Date: 12-10-2021

Project Name: SETA Northview Early Learning Center TI and Site Improvements  
WP Project Number: 210001.00  
Owner/District Project Number: NA

This Addendum consists of:

AS-101  
SITE PLAN

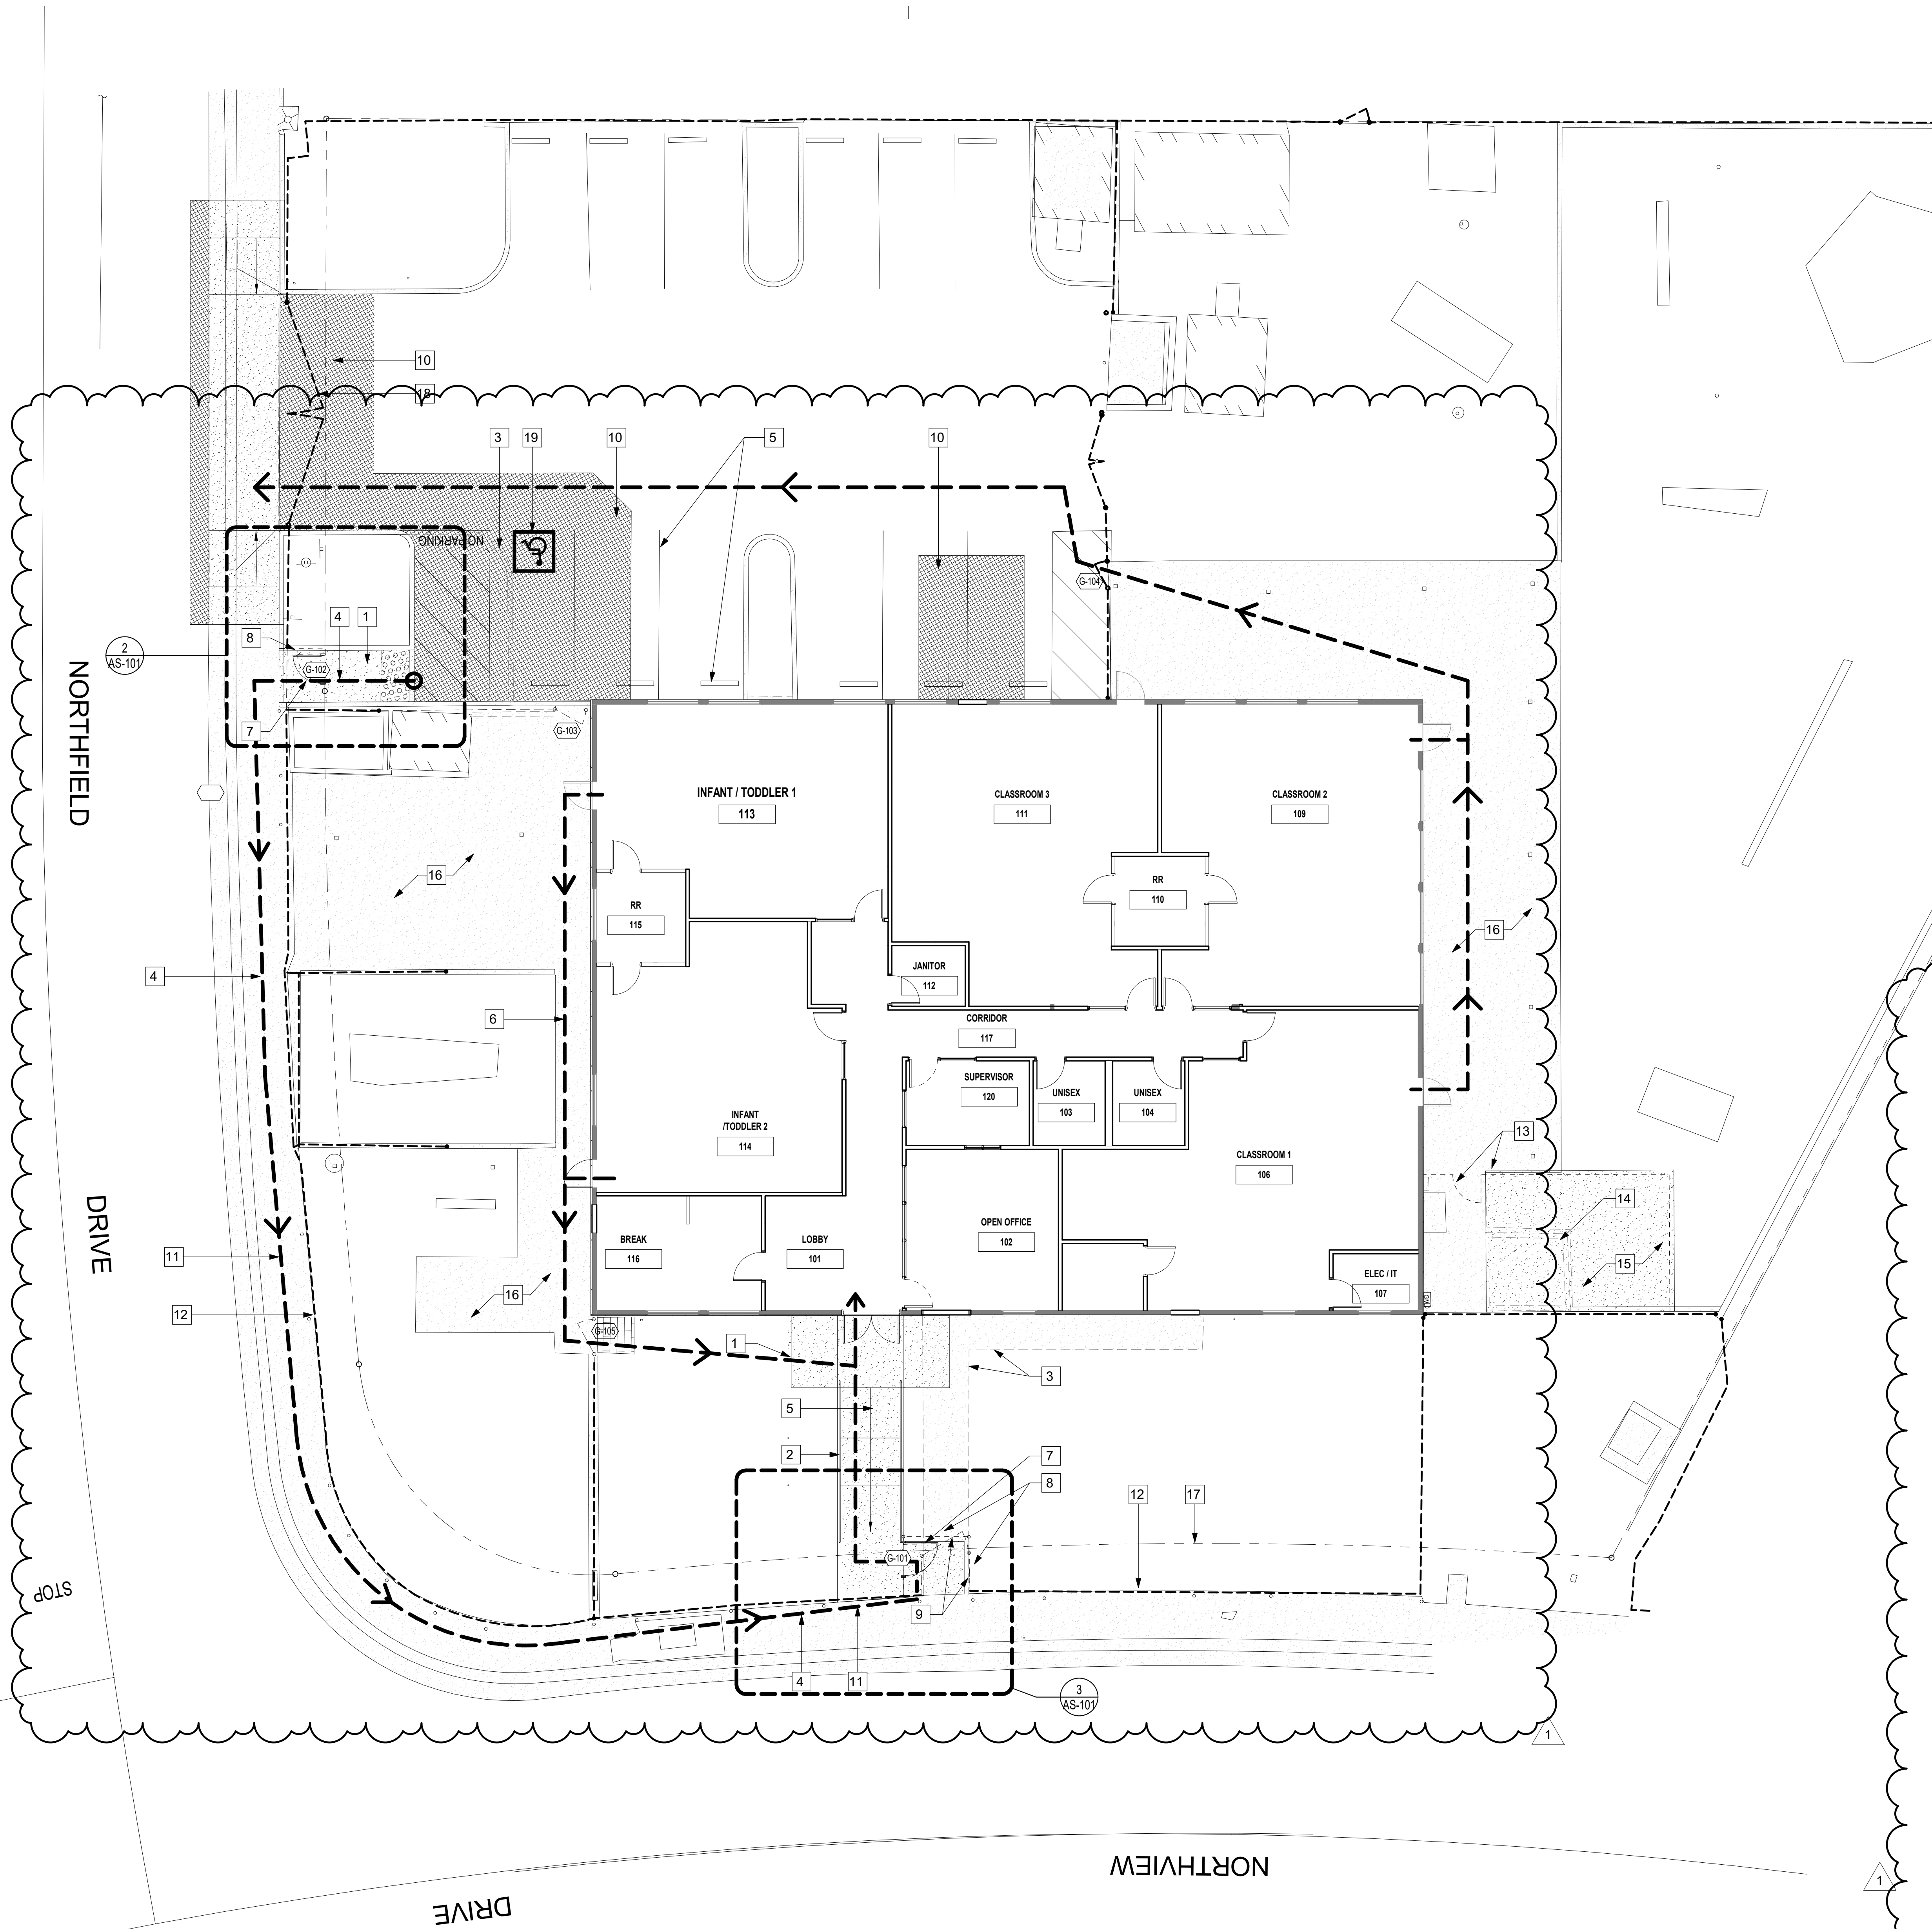
14. The extent of the new asphalt pavement & concrete walks shown in the parking lot on AS-101 do not match what is shown on C1.1 & C1.2. Please advise which is correct.

**Response: New asphalt per Civil drawings.**

**AD-111**  
DEMOLITION FLOOR PLAN

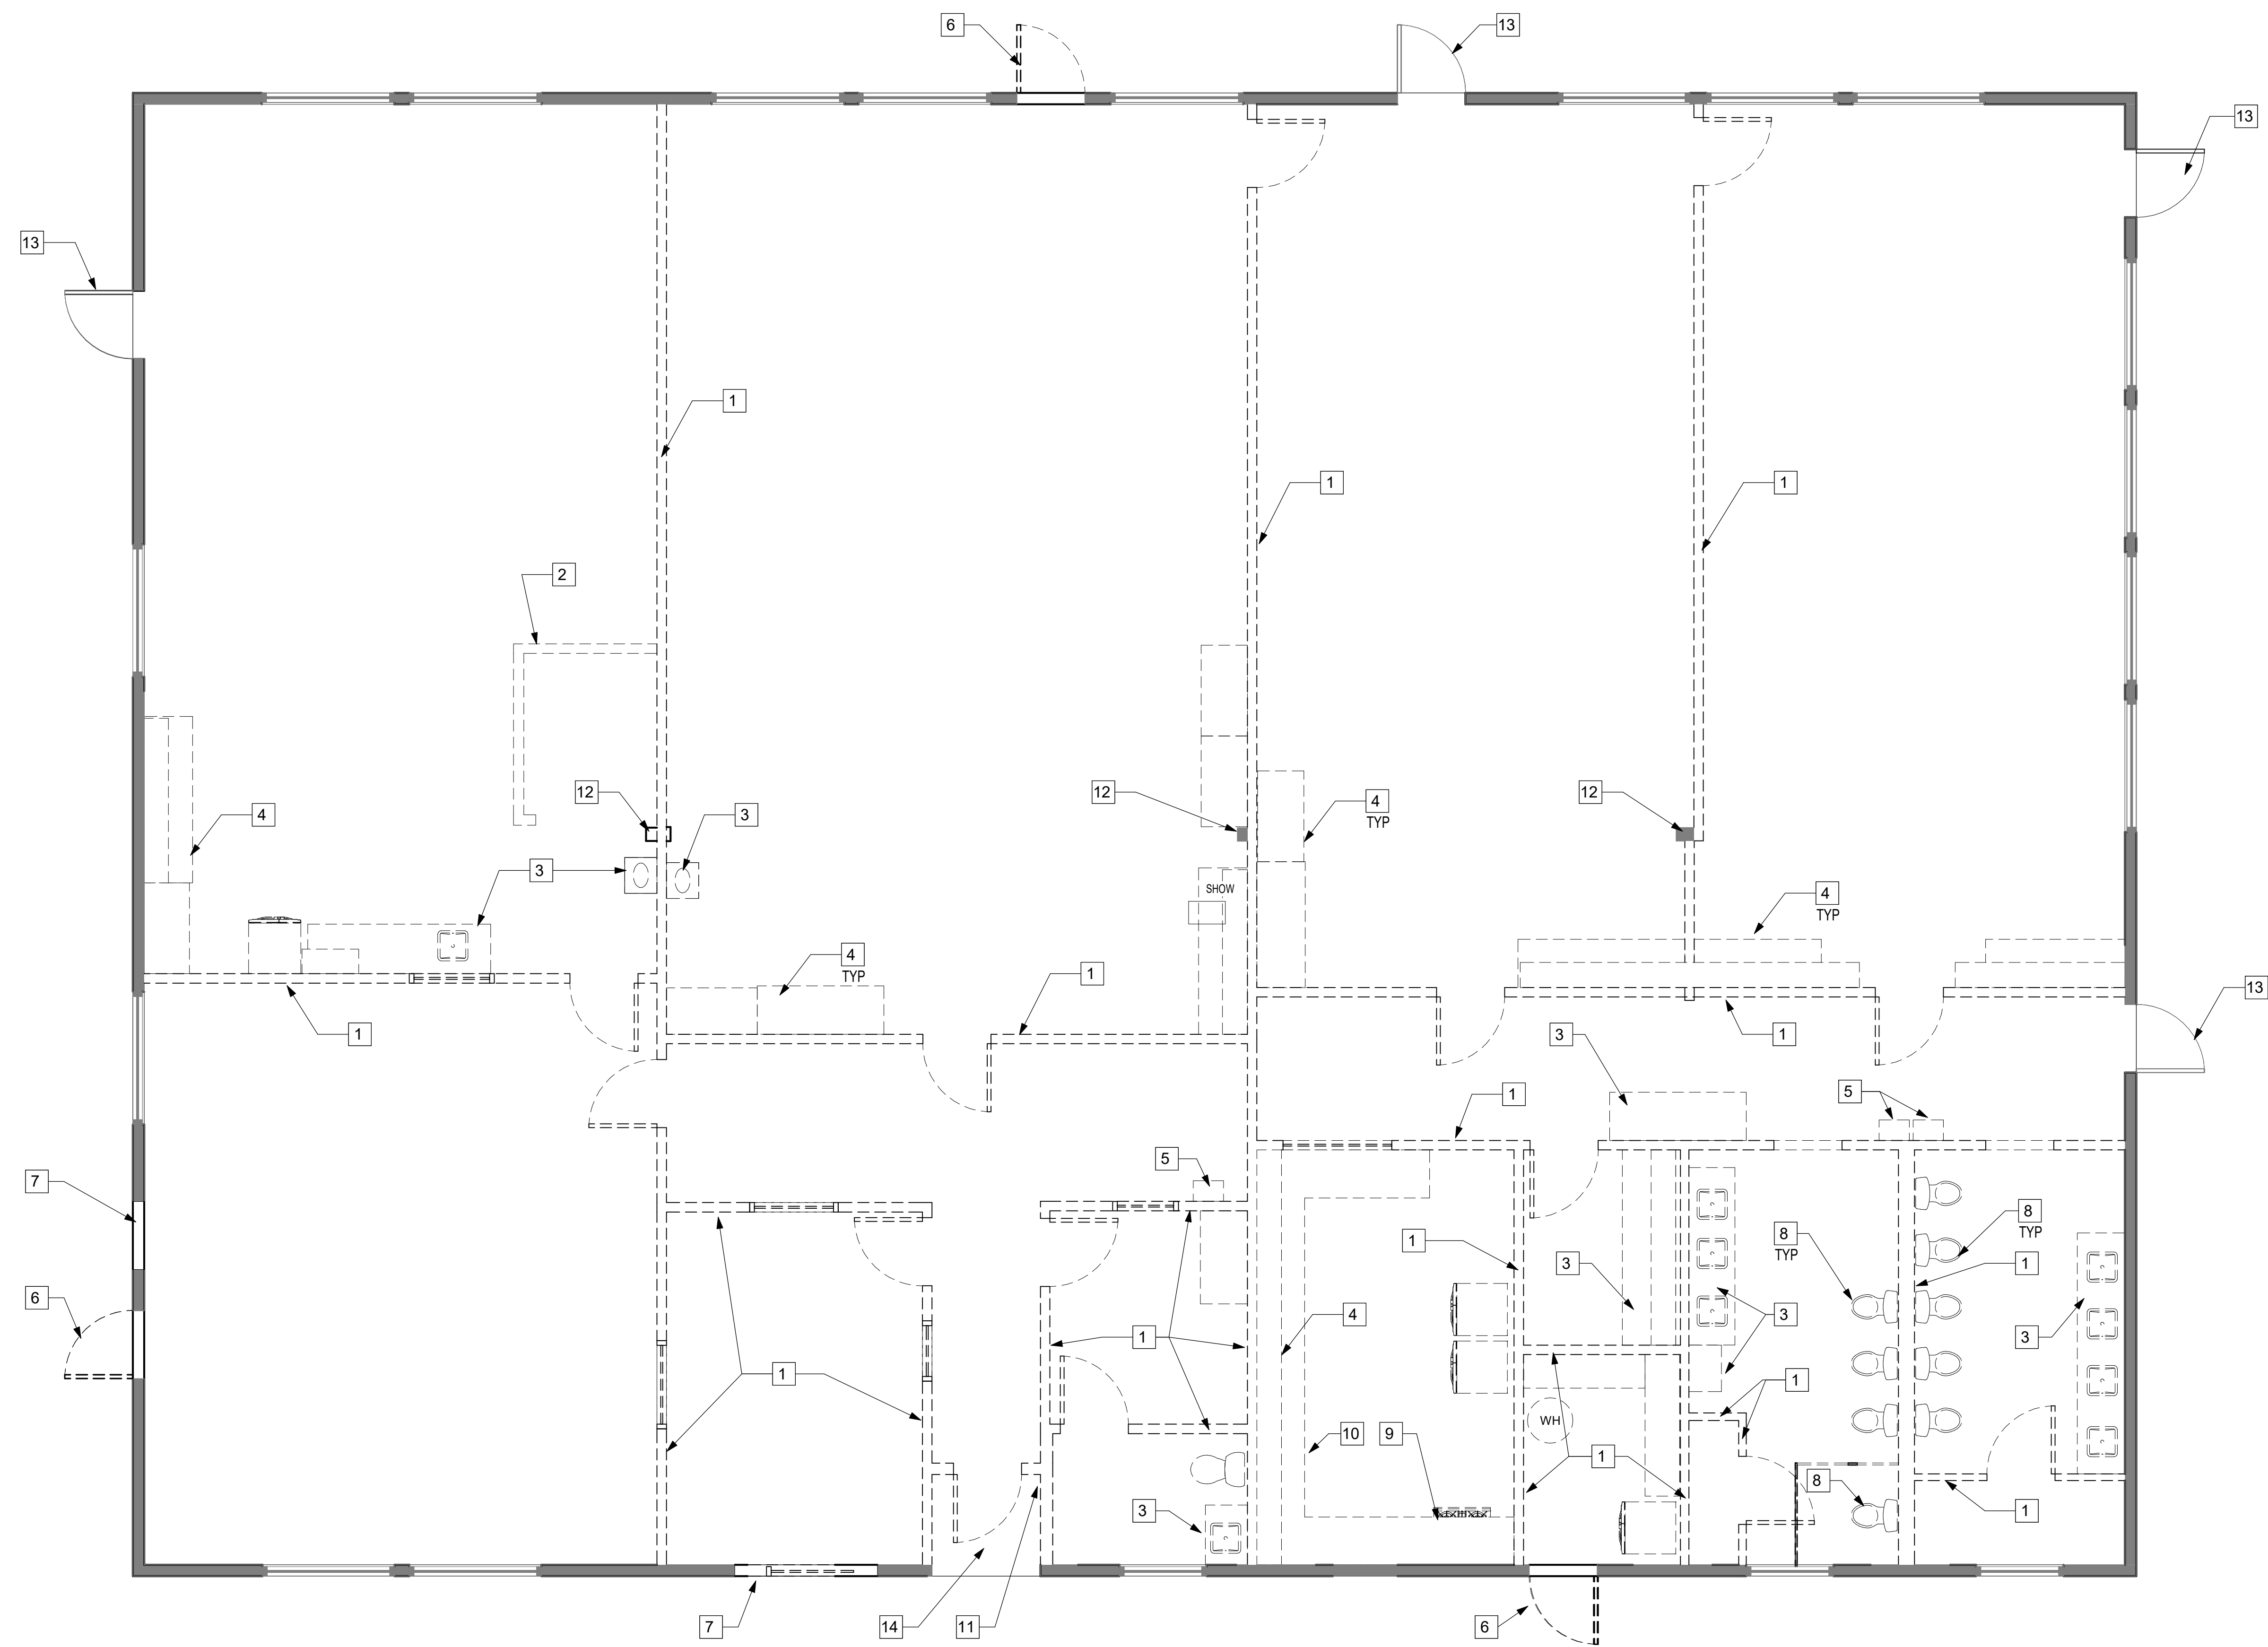
15. In doing a comparative overlay with AD-111 and A-111 it seems that most if not all the existing walls that are not noted to be removed on AD-111 conflict with the new floor plan A-111. Please indicate all the walls that are to be demolished with on AD-111.

**Response: Demolition plans have been updated to clearly show the walls to be removed.**

11 TILE PATTEN FOR ALTERNATE #1  
1/4" = 1'-0"

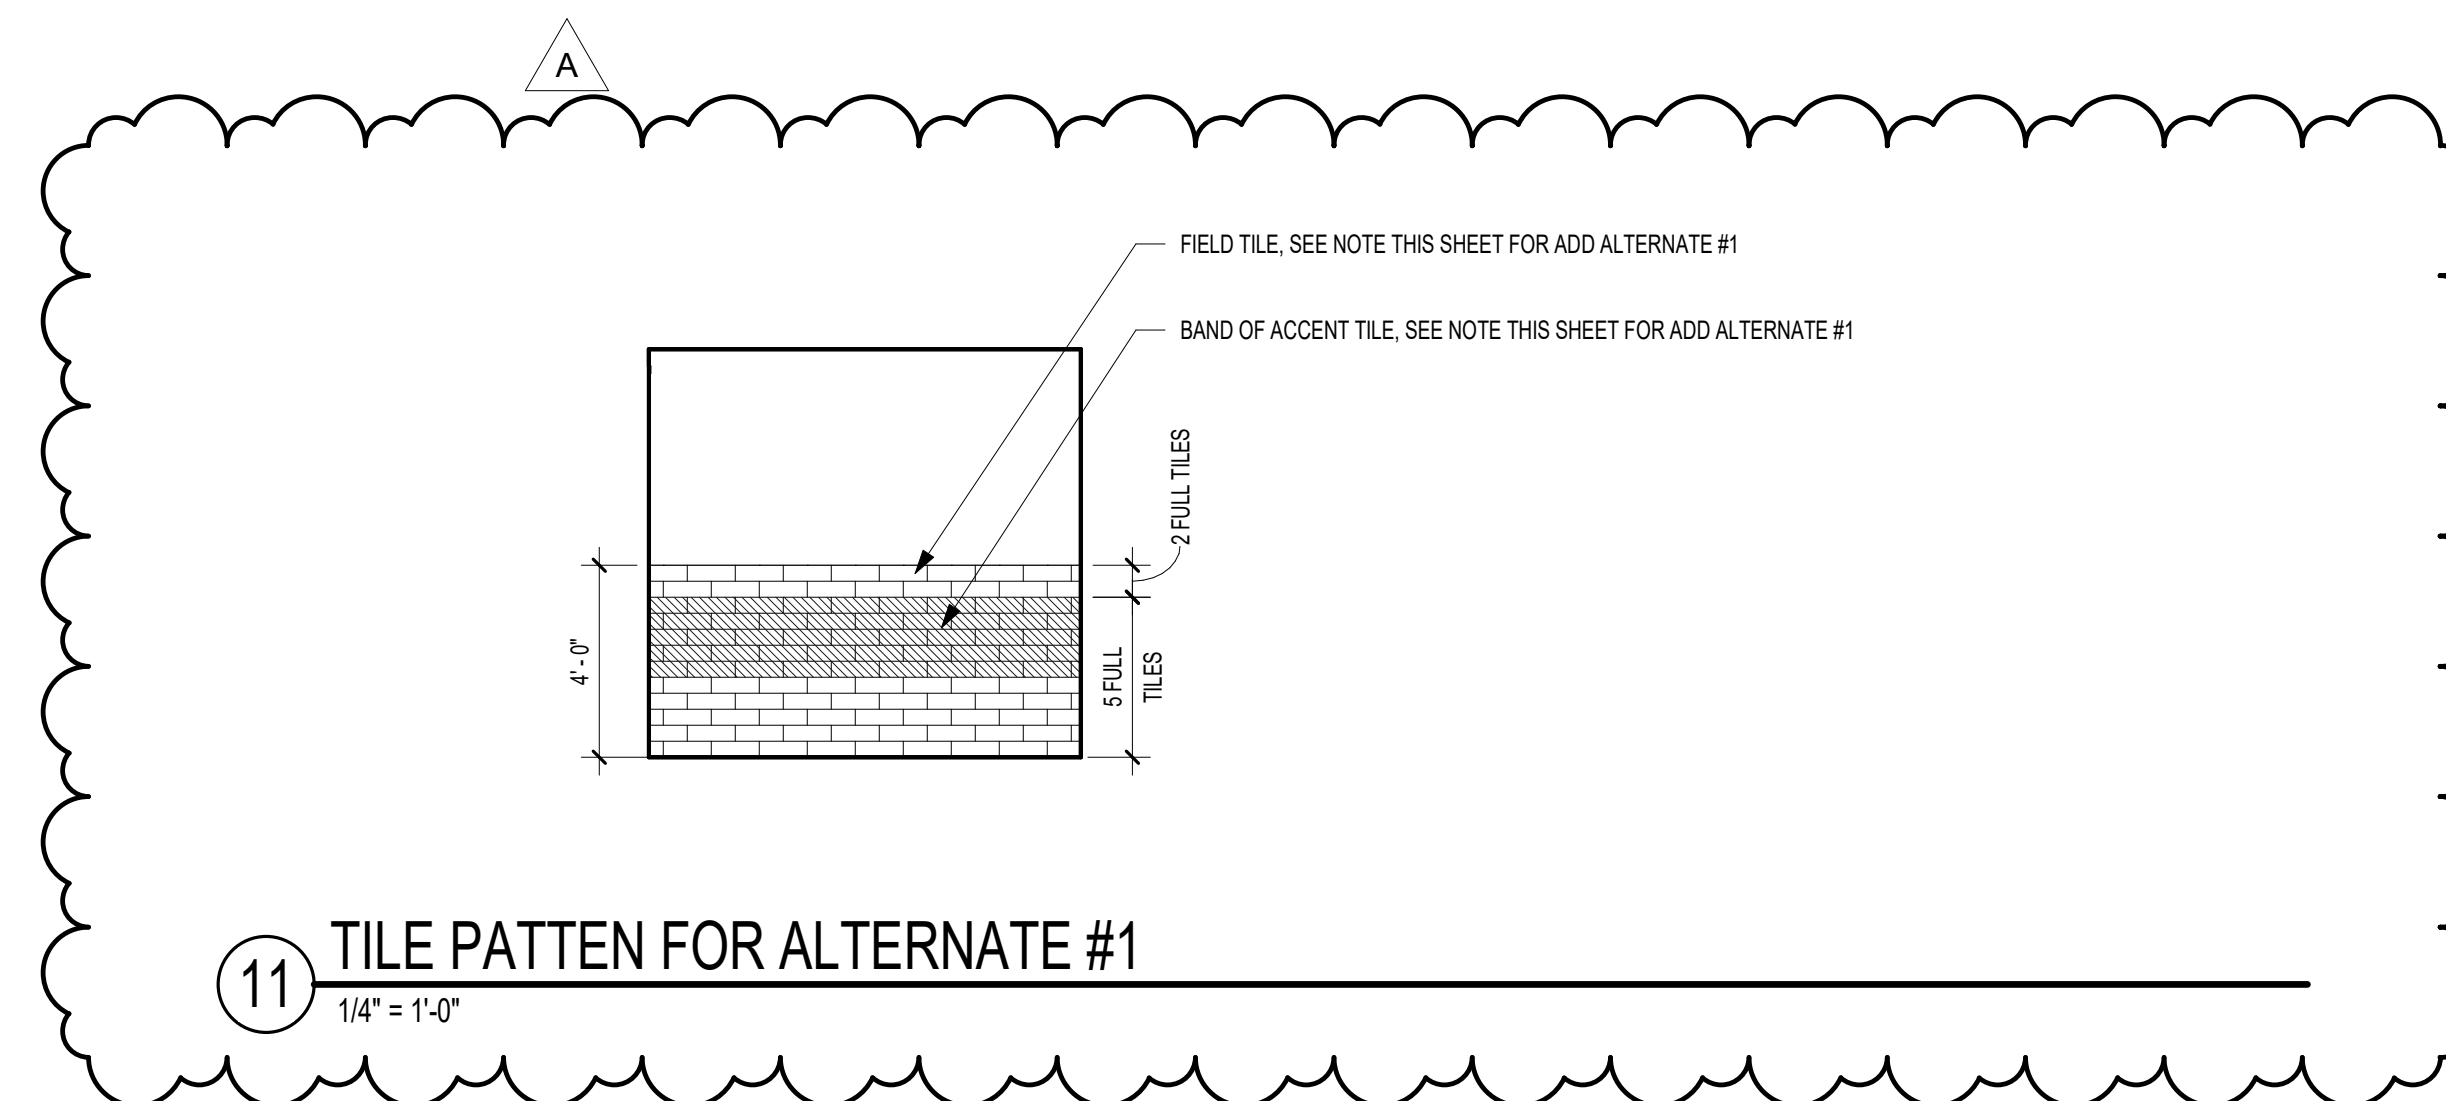
**Response: Yes, both trusses and conduits.**
10. A-541 – Finish Legend – Installation Notes for SP1 states See Alternate #1 on 11/A-411. There is not a detail 11 on sheet A-411. Please clarify.

19. Regarding Additive Alternate #1 is the added ceramic tile to be the same height as the FRP that is shown?

**Response: See detail 11 / A-412 for Alternate #1**

**Response: As shown in detail 11 / A-412 the height of Add Alt #1 tile will be the same as the FRP.**
